STATE OF NORTH CAROLINA
DEPARTMENT OF TRANSPORTATION

Subject: **Request for Modification Individual Section 404 Permit and Section 401 Water Quality Certification for the Central and South sections of the I-77 HOT Lanes Project, I-5405 and I-3311C.**

Reference: **Individual 404 Permit** SAW-2012-00156 issued January 28, 2016 for the Central Section and subsequent modifications issued for the North Section on May 20, 2016, and South Section on November 24, 2016.
Individual 401 Water Quality Certification No. WQC004036 issued November 13, 2015 for the Central Section, and subsequent modifications issued for the North Section on February 15, 2016 and South Section on May 16, and June 28, 2016.

Site 6-C:

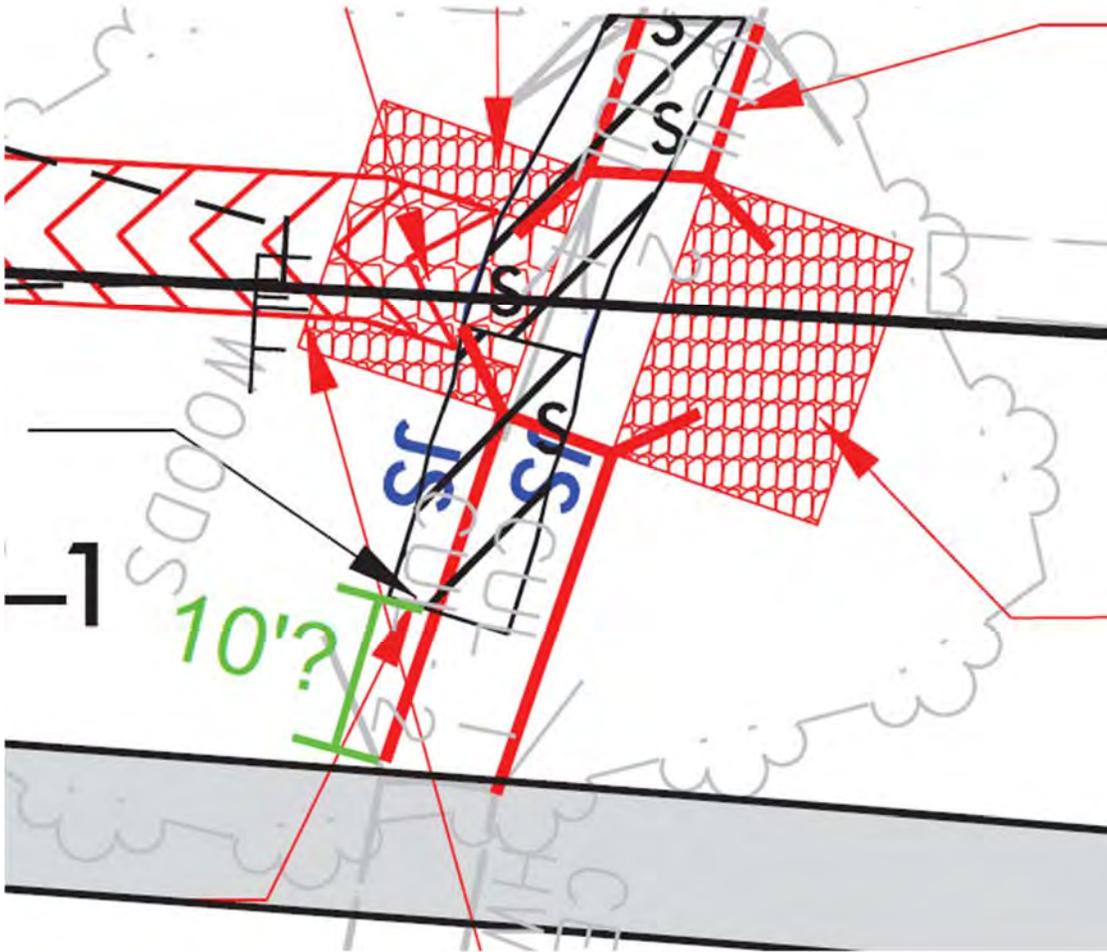
Site 6-C: 8' x 7' culvert extension to the median

The original/ permitted impact from culvert extensions was 26 linear feet of permanent stream impact, 21 linear feet of stream embankment, and 42 feet of temporary stream impacts for de-watering and construction access.

When looking closely at the drawings (magnified below), it is noted that the measurement of the extension was based on the "JS line" instead of the existing culvert.

This discrepancy results in a 10 linear foot deficit of permanent stream impact (noted in green below). The impact summary table has been revised to reflect the increase from 26 to 36 linear feet of culvert extension.

Site 7-C: (2) 10' x 8' culvert extension to the median

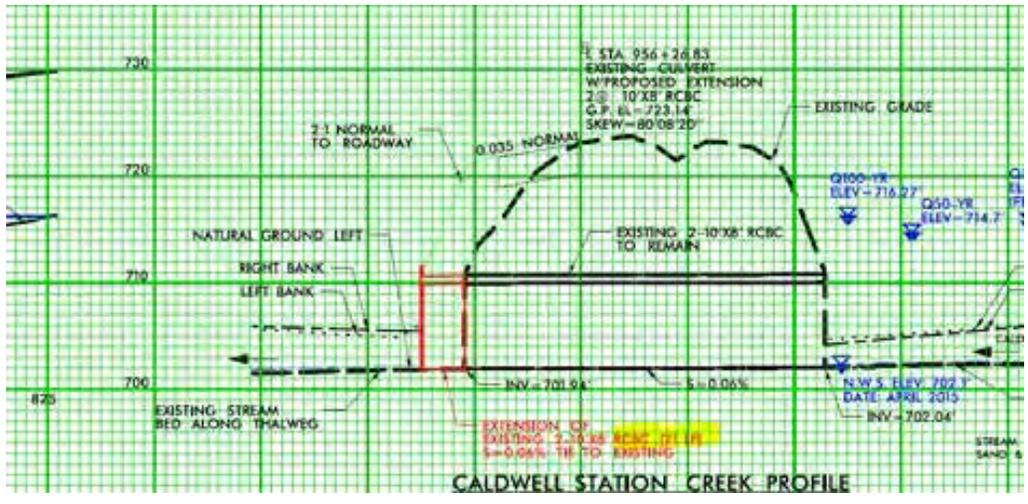
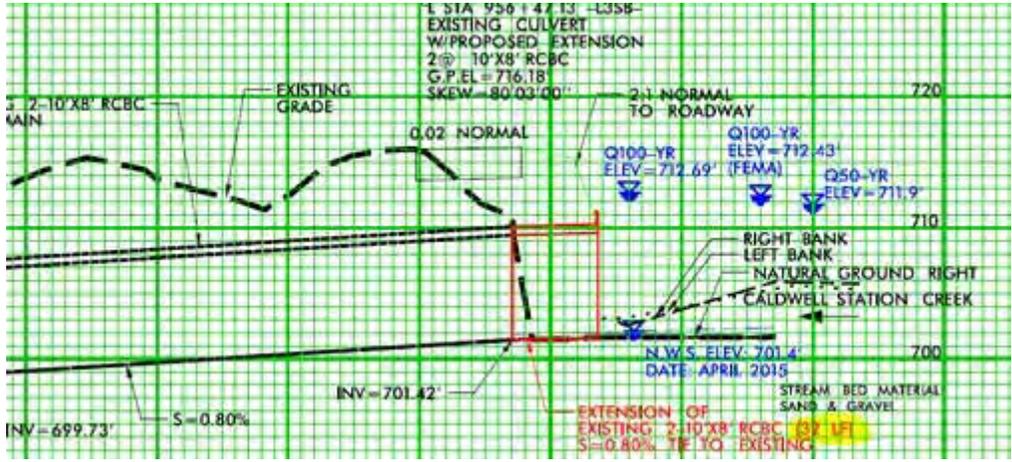
The original/ permitted impact from culvert extensions was 69 linear feet of permanent stream impact, 22 linear feet of channel protection, 99 linear feet of stream bank stabilization, and 40 linear feet of temporary stream impacts for de-watering and construction access.

Plans (below) now indicate that only 53 linear feet of culvert extension is required.

This change results in a surplus of permanent stream impact of 16 feet. The impact summary table has been revised to reflect the decrease from 91 to 75.

**PERMIT DRAWING
SHEET 12 OF 35
Revised 5/19/2017**

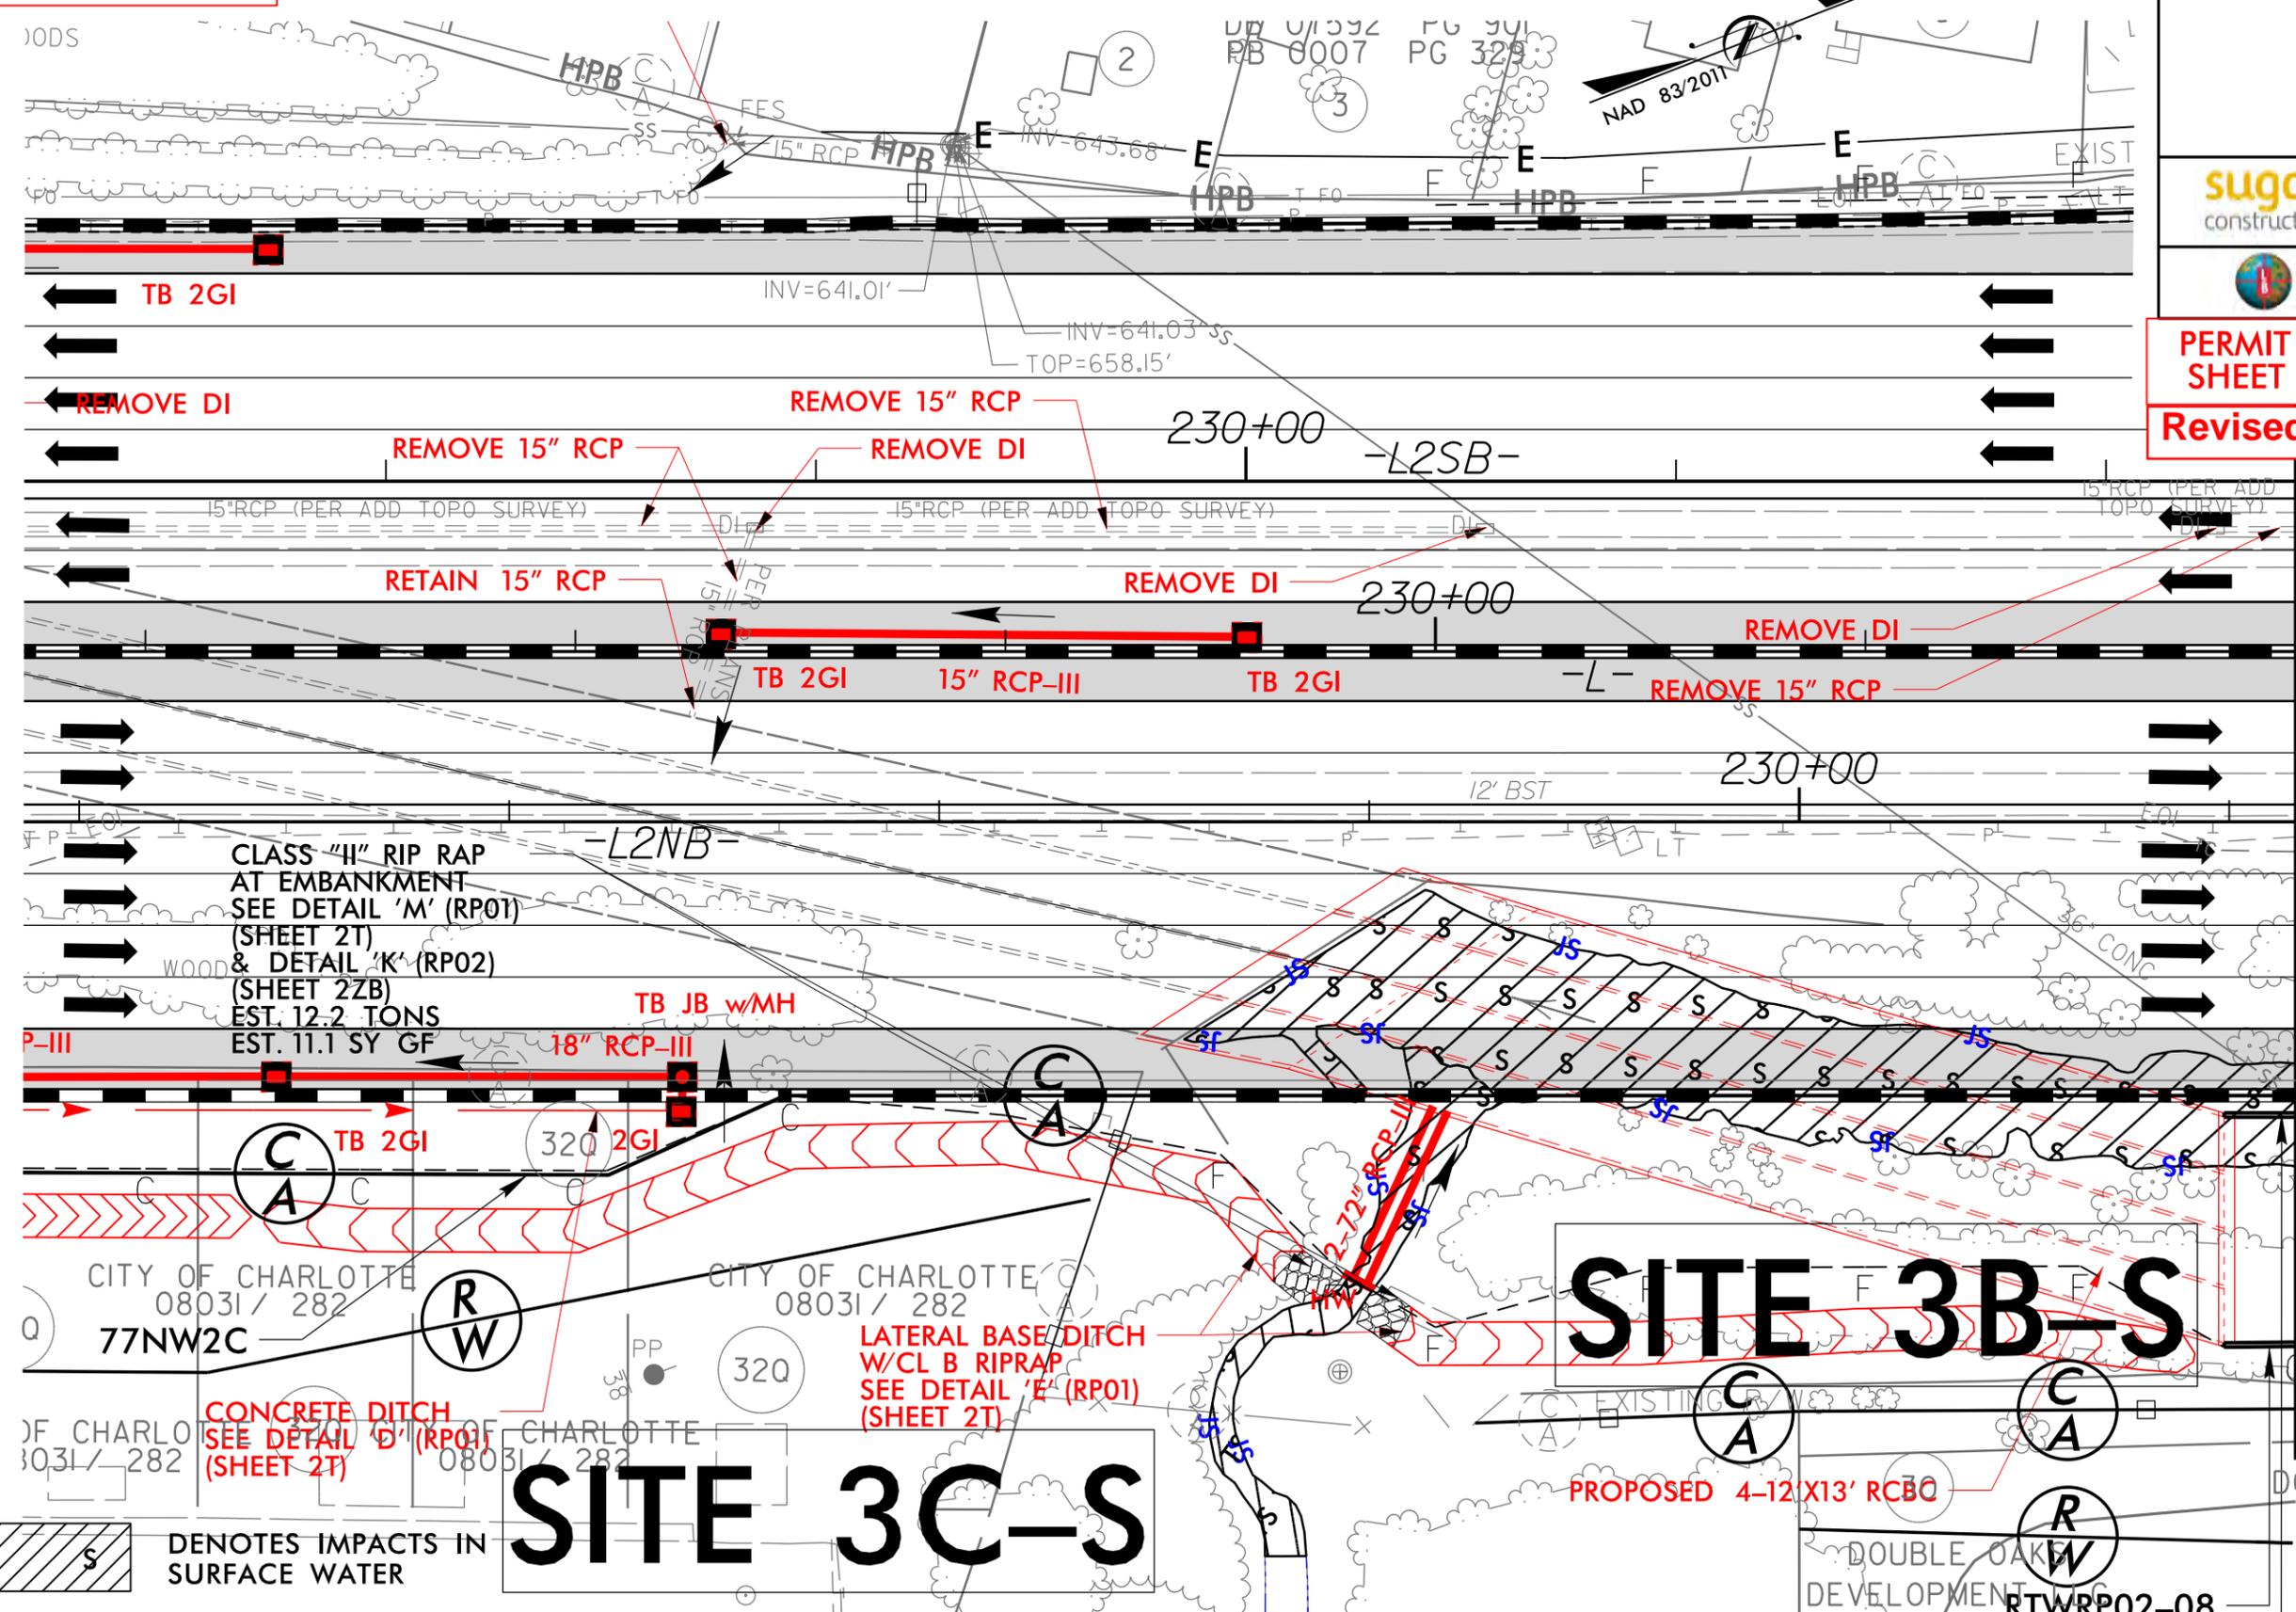
Site 3C-S: UT to Irwin Creek that outlets into the Irwin Creek culvert extension

The original/ permitted temporary impact for construction access, managing water flows, and reworking the riprapped banks was 45 linear feet of temporary stream impact, and 45 linear feet of permanent stream impact for the installation of a 72” pipe.

The team requests an additional 40 linear feet of temporary access/dewatering impact for a total of 85 linear feet, which will allow them to construct the Irwin Creek culvert at a more productive and safer location and sequence. This will also facilitate faster construction of the culvert, and reduced temporary fills in Irwin Creek, resulting in less time/exposure to high flow events while under construction. Please find attached revised Sheet 12 of 35 displaying this modification.

[This change results in the addition of 40 linear feet of temporary access/ dewatering. The impact summary table has been revised to reflect the increase from 45 to 85 linear feet.](#)
